## #203470 Hurricane 200 Driven Shaft Installing

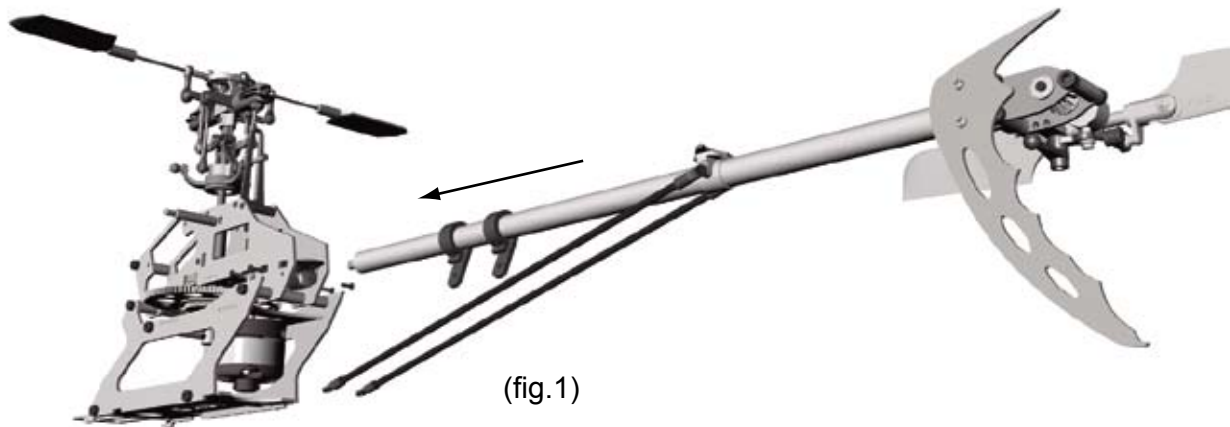
The Main gear assembly should be displaced by the item #203541 which the direction of the one way bearing is different from the Main gear of the belt version #203540.

The Middle plate should be displaced by the item above which had the space for pinion gear.

The top of the upper pinion should be aligned with the top of the motor shaft.

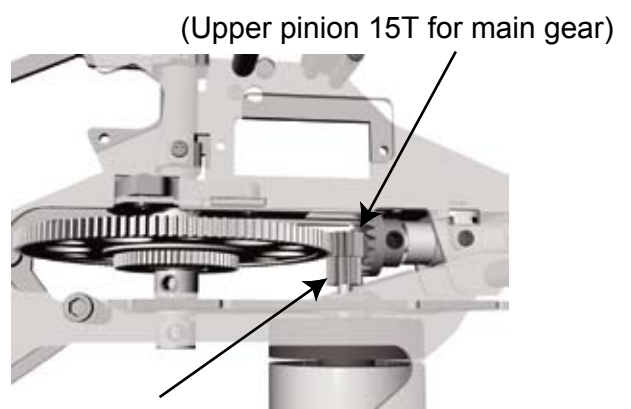
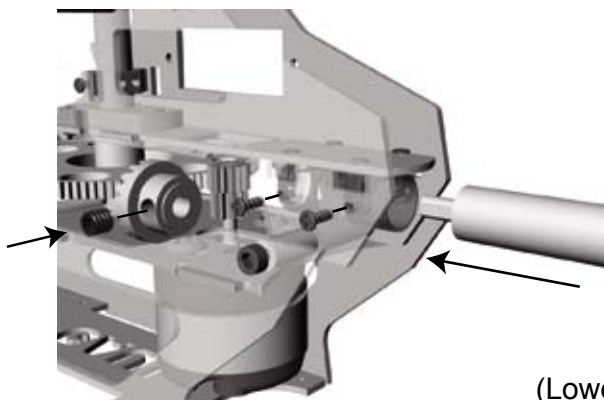
Insert the tail shaft assembly into the boom holder (fig.1), install the crown gear onto the driven shaft , adjust the gear mesh and tighten the screws of the boom holder(fig.2).

If you use the main gear assembly of the belt version #203540, make sure to reinstall the inside one way bearing up side down and remove the cover. The installing direction of the main gear is different from the belt version as shown in fig.3, the lower pinion must not touch the main gear.
